The Division of Reclamation, Mining and Safety has conducted an inspection of the mining operation noted below. This report documents observations concerning compliance with the terms of the permit and applicable rules and regulations of the Mined Land Reclamation Board.

MINE NAME:	MINE/PROSPECTING ID#:	MINERAL:	COUNTY:
Cañon Dolomite Quarry	M-1977-376	Dolomite	Fremont
INSPECTION TYPE:	INSPECTOR(S):	INSP. DATE:	INSP. TIME:
Monitoring	Timothy A. Cazier	March 11, 2014	09:30
OPERATOR:	OPERATOR REPRESENTATIVES:	TYPE OF OPERATION:	
Continental Materials Corporation	Andre Laroche, Gary Tuttle, Daniel Tezak	112c - Construction Regular Operation

Photo 1. Permit identification sign (Note: previous Operator name).

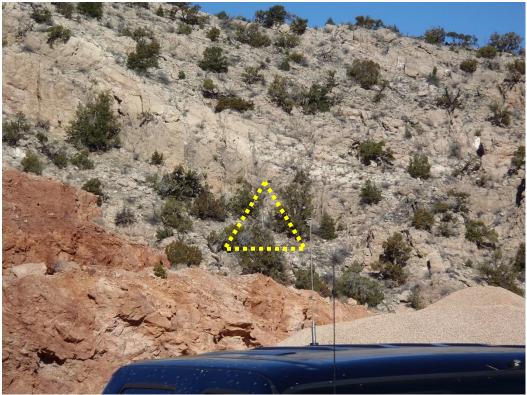
PROBLEM/POSSIBLE VIOLATION: Problem: The Permit was transferred from Castle Concrete Company to Continental Materials Corporation in 2003. The Permit Sign still lists Castle Concrete as the Operator.
CORRECTIVE ACTIONS: Correct the Operator name to Continental Materials Corporation on the Permit Sign and submit photographic documentation demonstrating the correction by the Due Date.
CORRECTIVE ACTION DUE DATE: 3/13/15

A permit sign was displayed at the site entrance (see **Photo 1**). However, the sign list the previous Operator, Castle Concrete instead of Continental Materials. **The wrong name is cited as a problem on page 1 of this report**. The permit boundary appeared to be marked with PVC poles (see **Photo 2**). However, the permit boundary is considerably larger than the planned affected area, so not all the markers were visible from the pit area.
